# Service Bulletin

82

## L-107 AND L-157 LAWN RANGER

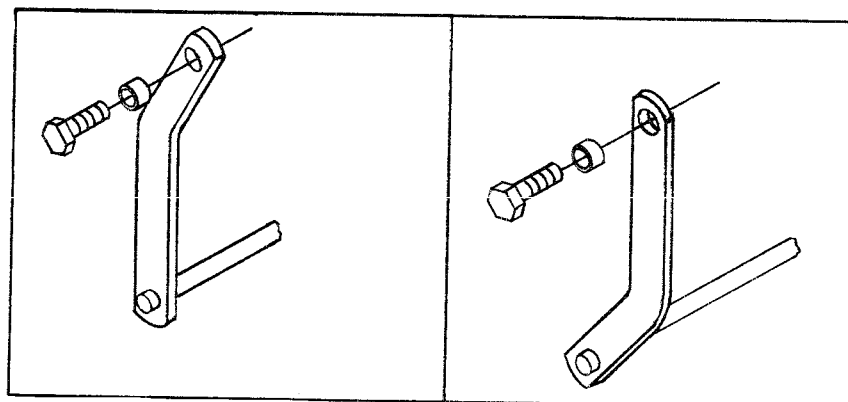
Scattered reports have been received indicating interference of the #6324 mower hanger link when raising the mower to the travel position. Should this problem be experienced, it may be corrected by removing the two front mower links #6324, and turning them 180°, end for end, as pictured below, and reassembled.

The short end and the bend should be downward.
